A Minor Amendment to a Site Development Plan for Building Permit approved prior to the effective date of the IDO to for minor changes to the exterior of the building including a new front entry, new colors and roof, mural, updated signs

RE: Administrative Amendment - Tula's Kitchen
Planning case file: 03EPC 01665 / Project# 1003009

The applicant for the property located at 5021 Pan American Fwy NE, Tula's Kitchen, is requesting an administrative amendment to the Jefferson Commons Site Development Plan for Building permit. The applicant's intent is to renovate and re-brand the existing, vacant 6,432 square foot restaurant into a Tula's Kitchen II restaurant. As part of the scope of renovations, the applicant is proposing to make minor changes to the existing signage, exterior façades, and roof materials.

FRONT ELEVATION

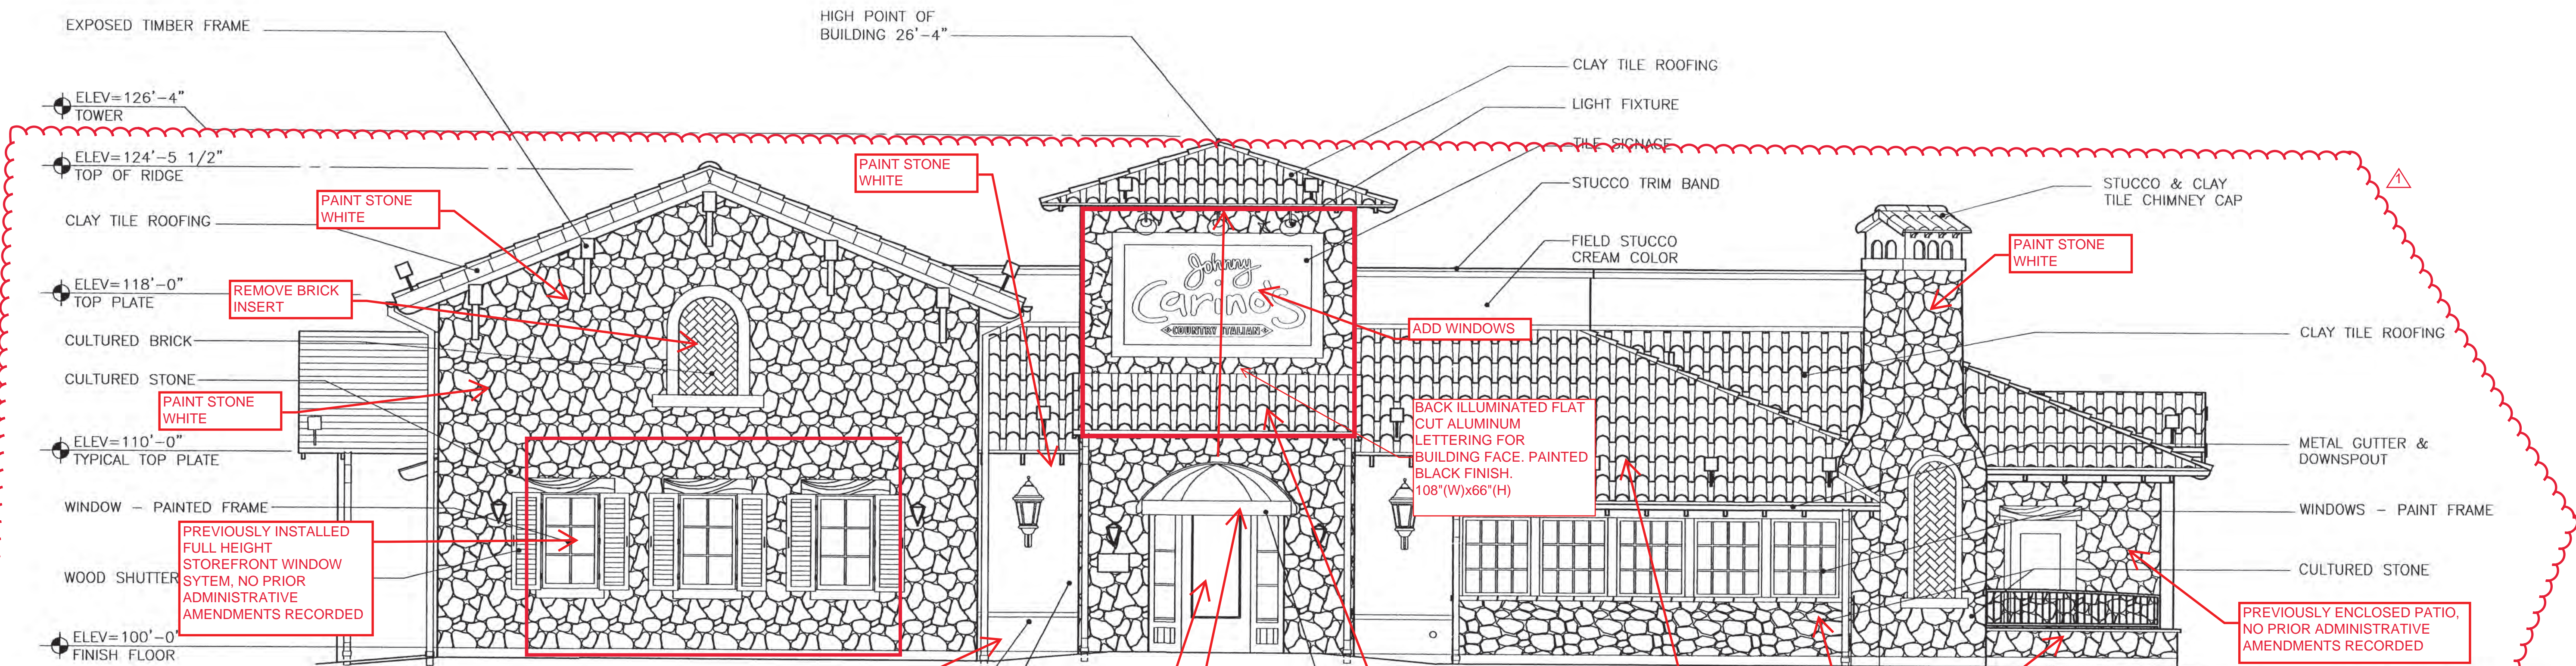
1. Extend height of existing entry to 23'-6" from 11'-6" and add windows to create a new decorative main entryway.
2. Paint existing stone white.
3. Remove existing stone below windows and install tile.
4. Add a new storefront door on the north side.
5. Change stucco color to white throughout.
6. Add painted mural at south wall at southeast corner.

PAINT STONE WHITE SW7551 (GREEK VILLA)
ADD WAINSCOT BROWN TILE (AVANA PLANK 8"x32")

RIGHT ELEVATION

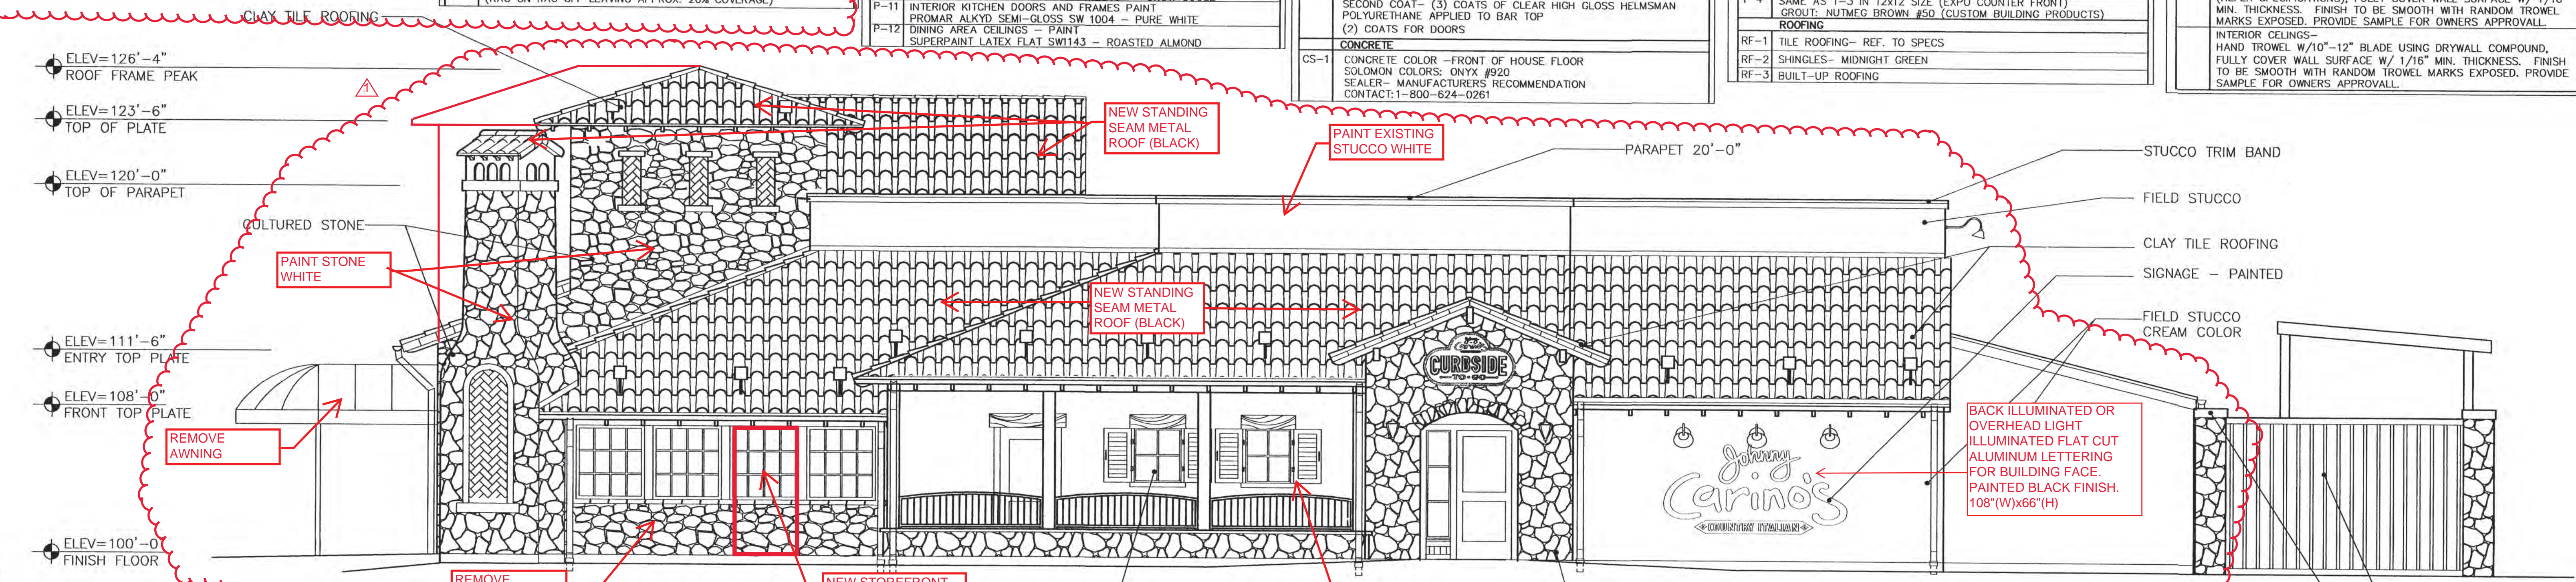
7. Remove brick details at south wall and east wall at southeast corner and at the existing chimney and infill with stone to match existing.
8. Replace fence material with horizontal simulated wood.
9. Install new black metal standing seam roof.
10. Paint existing trim.
11. Remove fabric awning at entry.
12. Replace signage with non-illuminated flat cut aluminum building mounted lettering for building face with painted black finish.
